HISTORIC AND DESIGN REVIEW COMMISSION

September 20, 2023

HDRC CASE NO: 2023-355
ADDRESS: 224 W MARIPOSA
LEGAL DESCRIPTION: NCB 9013 BLK 7 LOT 34 35, 36 AND 37
ZONING: R-4,H
CITY COUNCIL DIST.: 1
DISTRICT: Olmos Park Terrace Historic District
APPLICANT: Derek Rodgers
OWNER: Natalie Rodgers/PRO-SERV PROP
TYPE OF WORK: Door modifications
APPLICATION RECEIVED: August 21, 2023
60-DAY REVIEW: October 20, 2023
CASE MANAGER: Claudia Espinosa

The applicant requests a Certificate of Appropriateness for approval to replace the existing non-original front door with a modern five-lite door.

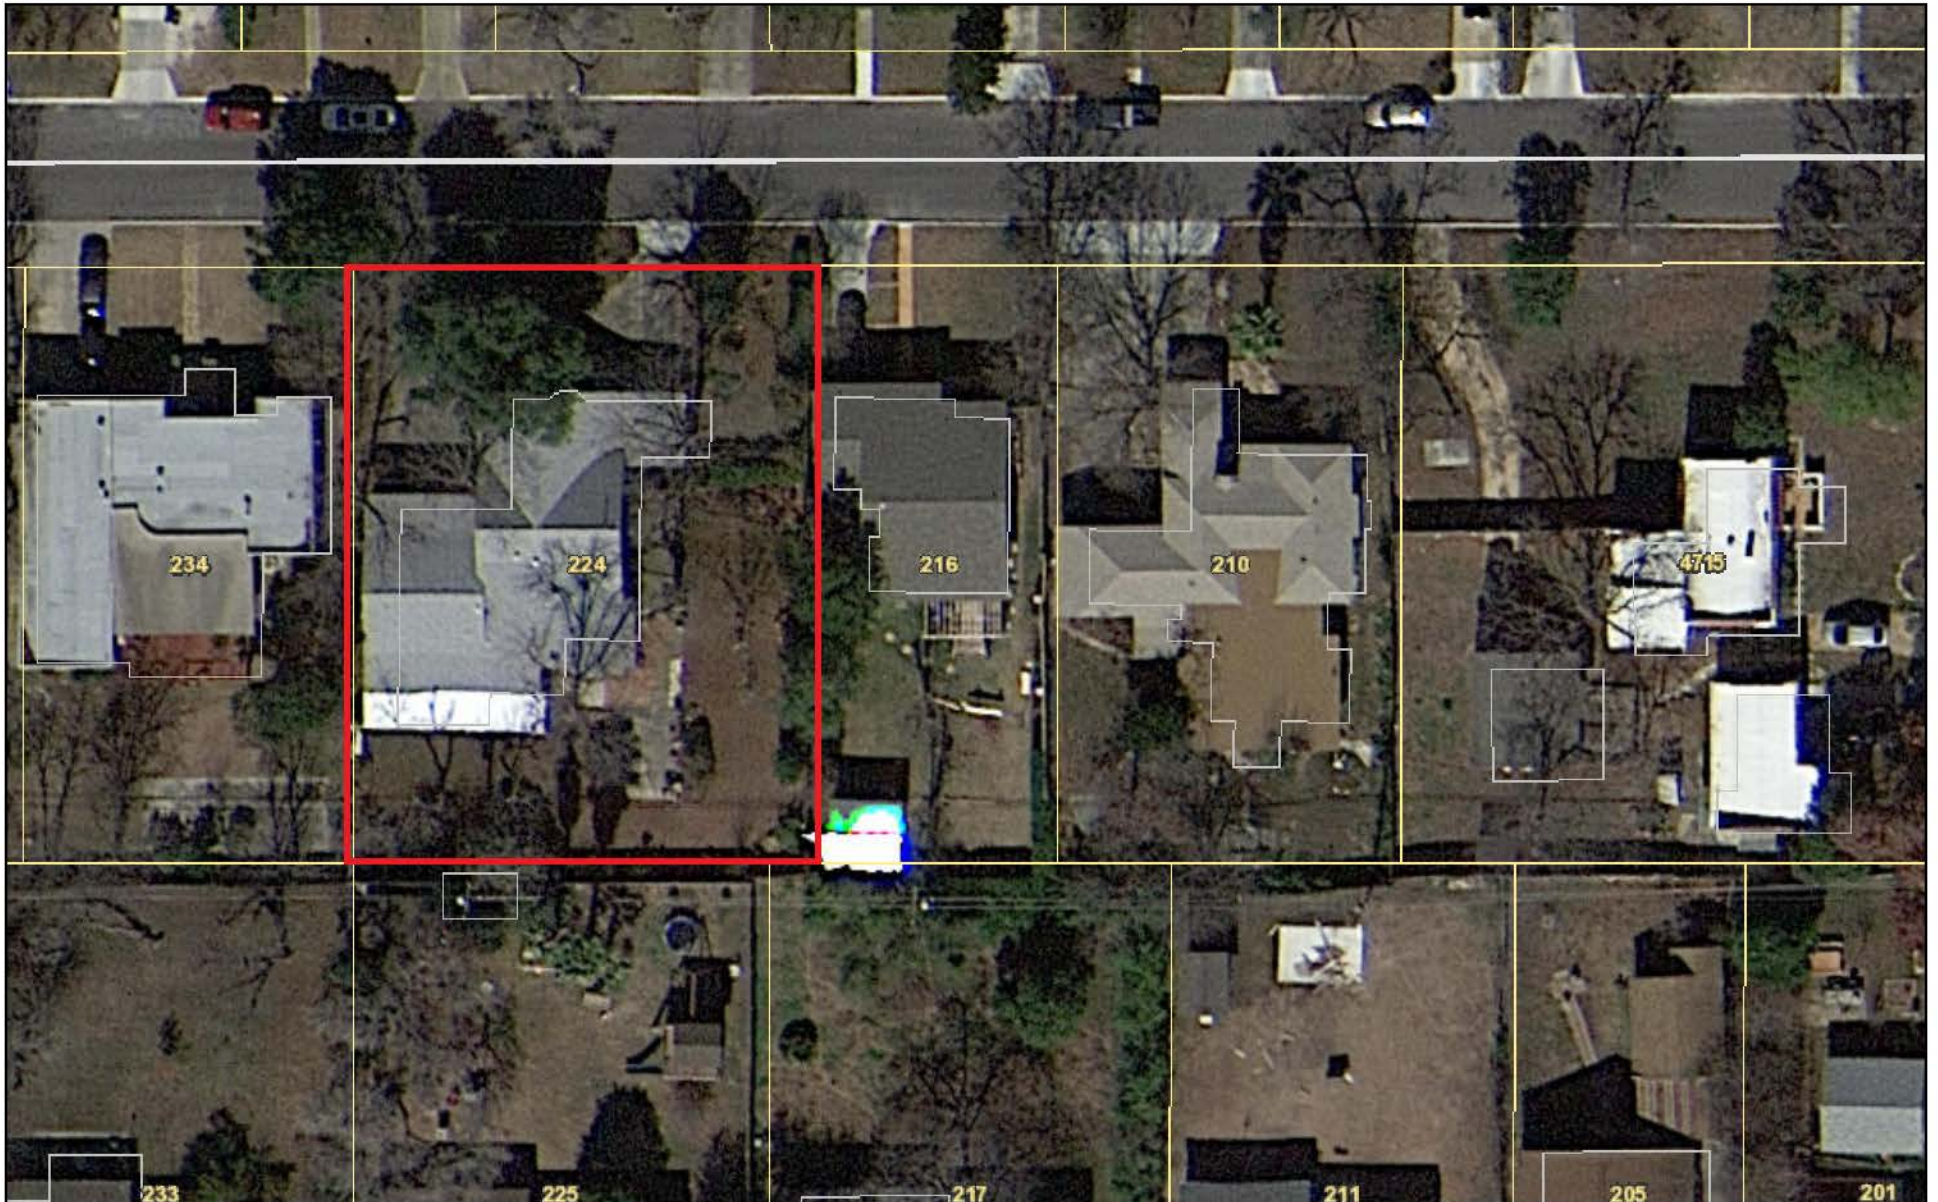
b. FRONT DOOR REPLACEMENT – The applicant is requesting to remove the front door and replace it with a modern front door. The Guidelines for Exterior Maintenance and Alterations 6.A.ii. states to preserve historic doors. In addition, the Guidelines for Exterior Maintenance and Alterations 6.B.i. states to replace doors in-kind when possible and when in-kind replacement is not feasible, to ensure features match the size, material, and profile of the historic element. The applicant has proposed a door that is not architecturally consistent with the style of the historic structure and is therefore inconsistent with the Guidelines. Staff finds that a Tudor style door should be installed.

Staff recommends approval based on findings a and b with the stipulation that a wood, Tudor style door be installed. The wood, Tudor style door is to be submitted to OHP staff for review and approval prior to the issuance of a Certificate of Appropriateness.
